## **Comments on windscreen/A-pillars as headform test area**

### **Conflicts with existing legal requirements (INF GR/PS/35)**

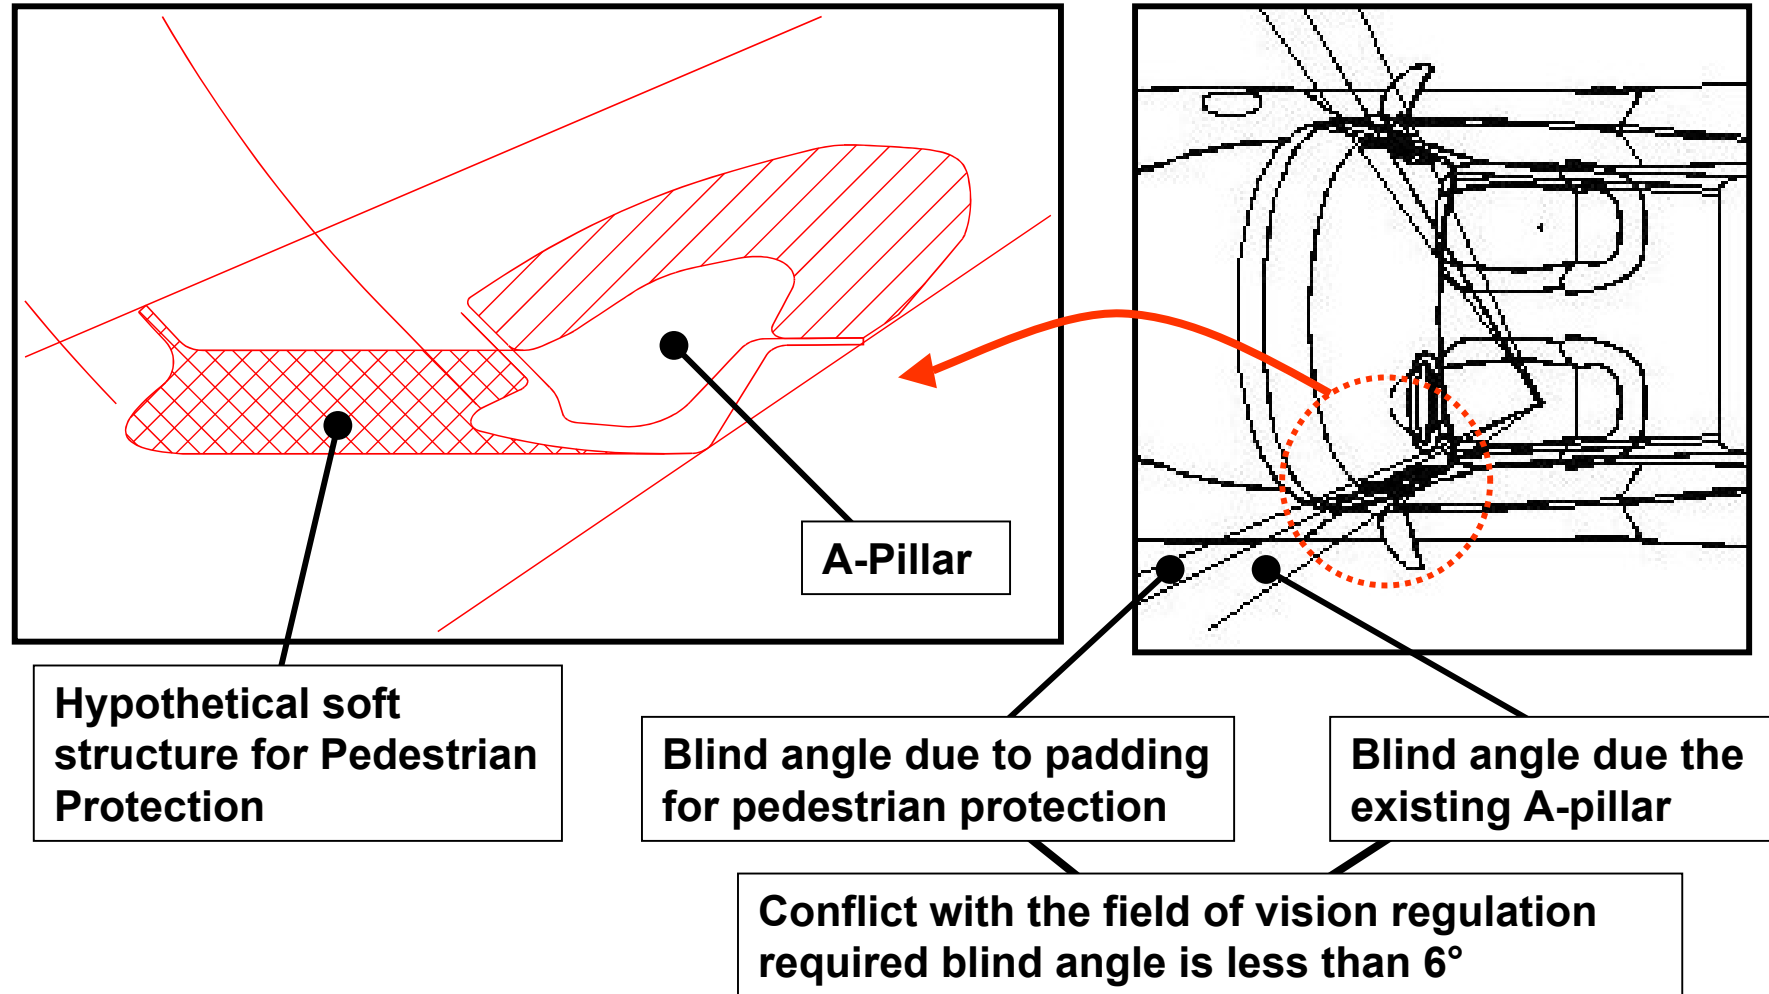
**To pass the proposed HIC<1000 a displacement of about 80mm is needed**

**Softening the A-pillars/windscreen is not feasible and contradicts strongly the roll over requirements**

**To provide enough displacement „on top“ is in contradiction to the field of vision requirement, European CO<sub>2</sub> agreement**
